## UTTAR PRADESH METRO RAIL CORPORATION LTD.

### ADDENDUM-4

**Name of work: AGCC-07:** Design and Construction of Main Line Elevated Viaduct from Agra Cantt. Metro Station to Kalindi Vihar Metro Station [Chainage (-77m to 15016m) including Viaduct Connection with Ramp (Chainage 0.00m to 2610m) from (nearby) Sadar Bazar Metro Station to existing Corridor-1 Depot at PAC ground & Corridor-2 Depot Entry/Exit lines Viaduct with Ramp (Chainage 0.00m to 530m) and 14 nos. of Elevated Stations i.e., Agra Cantt, Sadar Bazar, Pratap Pura, Collectorate, Agra College, Hariparvat Chauraha, Sanjay Place, M.G. Road, Sultanganj crossing, Kamla Nagar, Ram Bagh, Foundary Nagar, Agra Mandi & Kalindi Vihar metro stations including Civil, Associated Ancillary Structures, Architectural Finishes, Water Supply, Sanitary Installation, Drainage, External Development, Fire Fighting, Fire Detection, E&M works and PEB structures in Corridor-2 of Agra Metro at Agra, Uttar Pradesh, India.

TITLE: **SPAN ARRANGEMENT - AGRA CORRIDOR**  
 SHEET 27

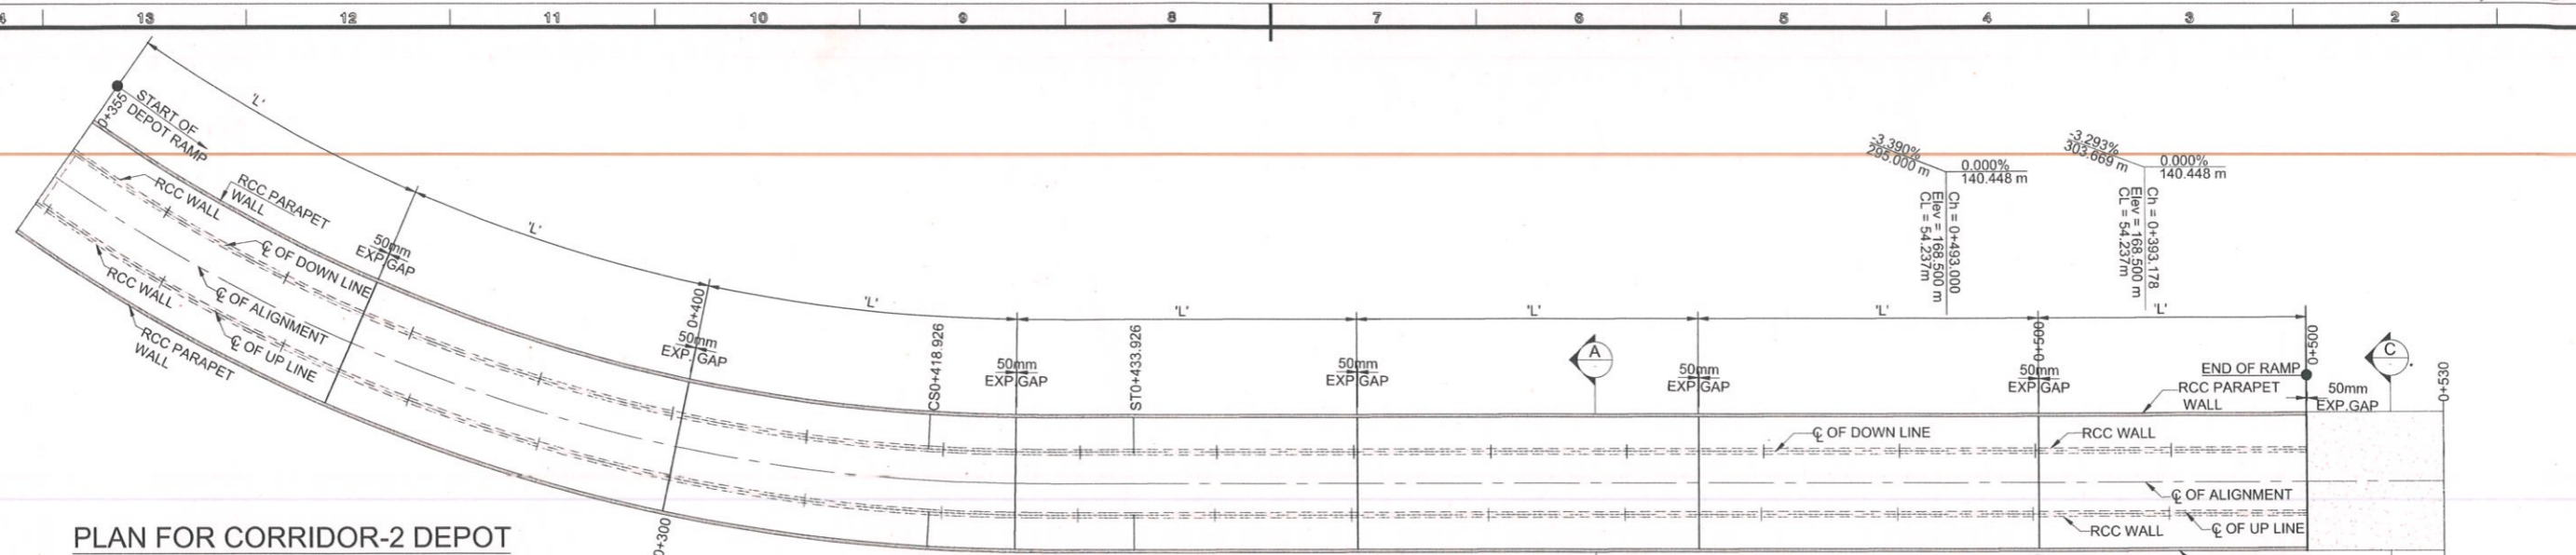
191	Vol-6 KNPAGDDC-01-TDR-ELV-VDC- DWG-09047	Span Arrangement-Agra Corridor	The alignment details for Ch. 430m to Ch.530m in the mentioned drawing are missing. Kindly provide. Further, kindly provide the co-ordinates of pier located at Ramp wall in drawing (KNPAGDDC-01-TDR-ELV-VDC-DWG-09056).	Kindly refer to <b>Annexure- 18 of Addendum</b> .

240	Vol_6_Drawing_1: Drawing No.– KNPAGDDC-01-TDR-ELV-VDC- DWG-09047(SHEET:27 OF 61)	"Alignment Plan & Longitudinal profile"	In Alignment plan, the location of Pier mark DPP-53 & DPP-52 is not available. Kindly provide the locations	As per tender Condition. Kindly refer Drg. No. KNPAGDDC-01-TDR-ELV-VDC-DWG-09044 of Tender Document.
241	Vol_6_Drawing_1: Drawing No. – KNPAGDDC-01-TDR-ELV-VDC- DWG-09044(SHEET:24 OF 61)	"Alignment Plan & Longitudinal profile"	The commencement of the Corridor-2 Depot Entry/Exit Viaduct at Chainage 0+000 occurs between DP-51 and DPP-52. However, it is essential to note that the alignment for the Corridor-2 Depot Entry/Exit originates from DP-51. The distance between DP-51 and the initiation point of the Corridor-2 Depot Entry/Exit Viaduct line is approximately 20 meters. Consequently, it is imperative to verify the length of the Corridor-2 Depot Entry/Exit Viaduct and ramp to ensure accuracy	As per tender Condition. Kindly refer Drg. No. KNPAGDDC-01-TDR-ELV-VDC-DWG-09044 of Tender Document.

TITLE: **SPAN ARRANGEMENT - AGRA CORRIDOR**  
 SHEET 8

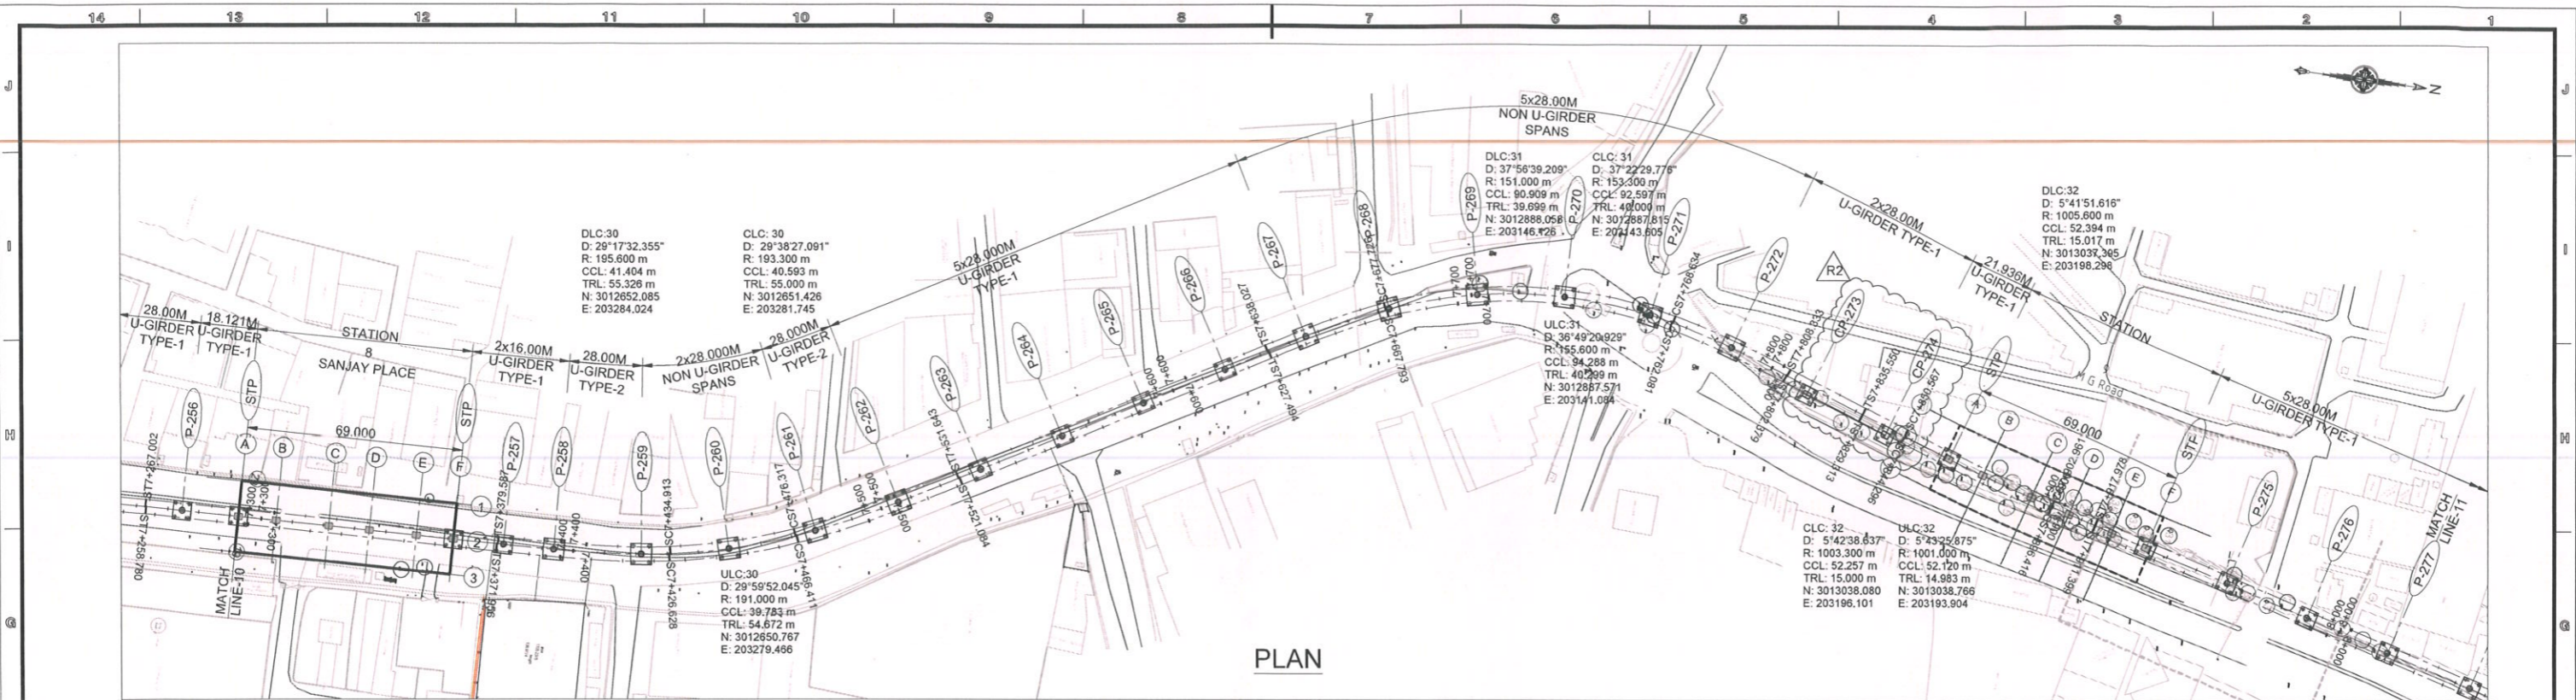
357	Volume 6 Drawing Sheet 8		Not specified From the Alignment GAD drawing, it is understood that there is future provision of Subhash Park Station from P191 A to P191 D. The employer is requested to confirm application of additional load and necessary changes arising in Pier caps/Cross arms to be considered for Future Station work referred to Subhash park mentioned in GAD from P191A TO 191D.	Provision for Future station are to be kept in foundation, substructure & superstructure. Kindly refer to <b>Annexure-1 of Addendum.</b>

TITLE: **SPAN ARRANGEMENT - AGRA CORRIDOR**  
 SHEET 12

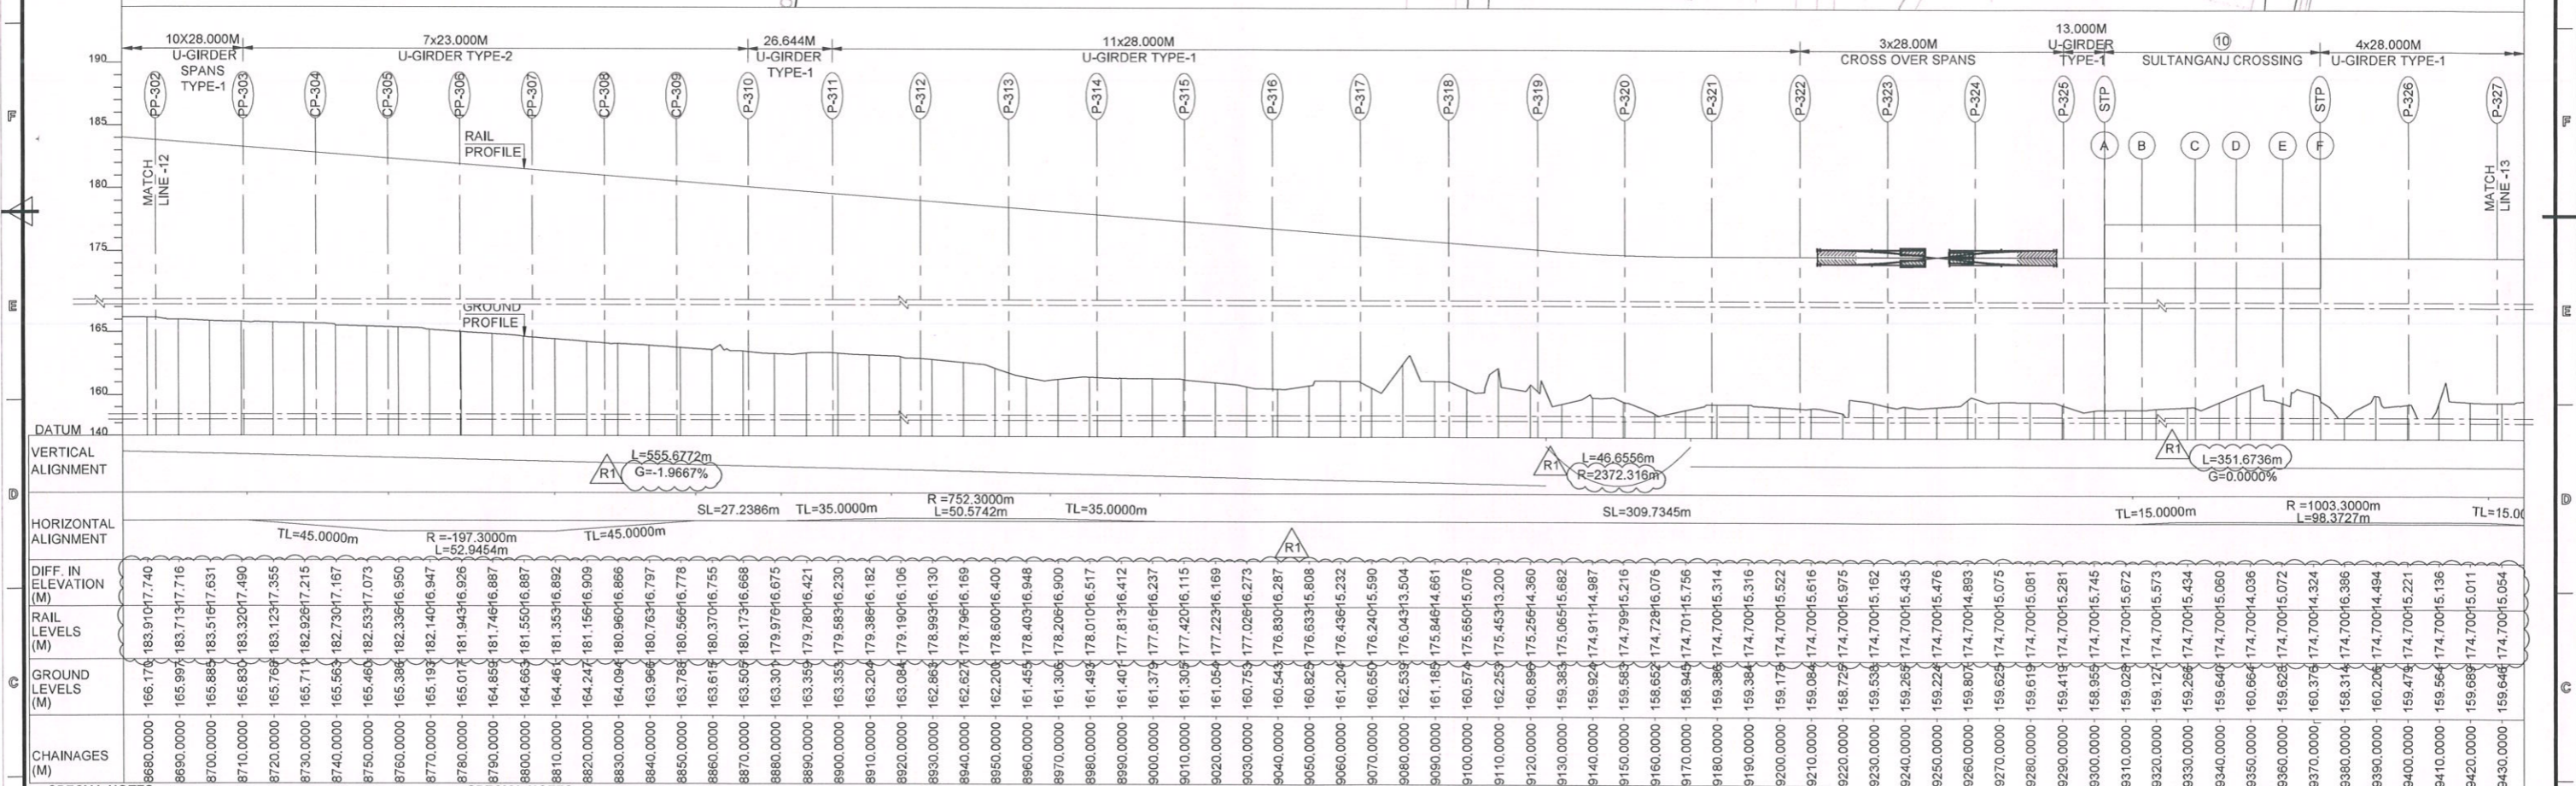
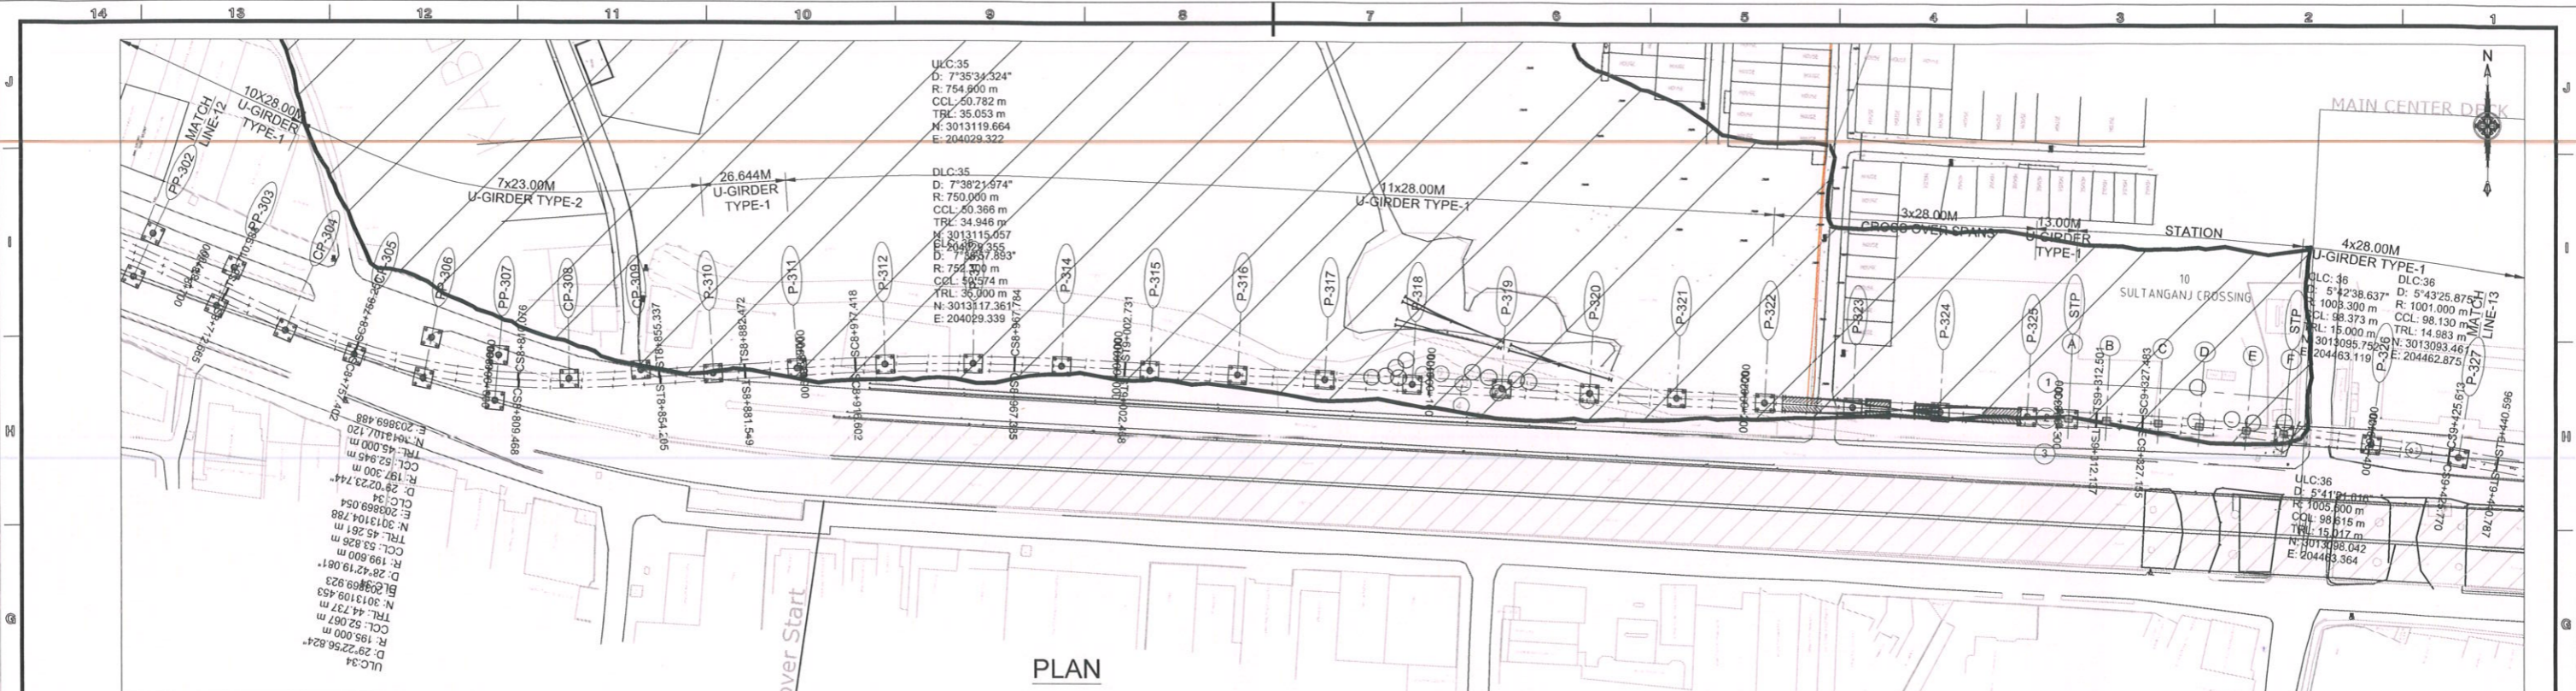
66	Vol-6, Tender Drawings	Title:- Span Arrangement-Agra Corridor Sheet 12 to 21 Drawing No.- KNPAGDDC-01-TDR-ELV-VDC-DWG-09032.	Along the NH, many of the Pier are coming over the drain along side of the highway & less space for launching of girder. <b>Please confirm</b> that at these locations, drain will be restored adjacent to Pier & additional width of ROW will be available for the same.	As per Tender Condition
67	Volume-1 ITT Annexure 12, Page No. 73	The figures indicated below are the minimum number of equipment required. 	Considering the scope cope of work the resources proposed are much on higher side than the normal requirement. There will be huge idling cost in cse there is delay due to various reasons. The resource will be deployed as per the requirement and approved schedule, also the min. number of pre-casting beds proposed are 40 (for U-girder) & this number is much higher for u-girder, 40 nos. beds includes U-girder, I-girder & segment? <b>Please confirm</b> .	As per tender conditions.
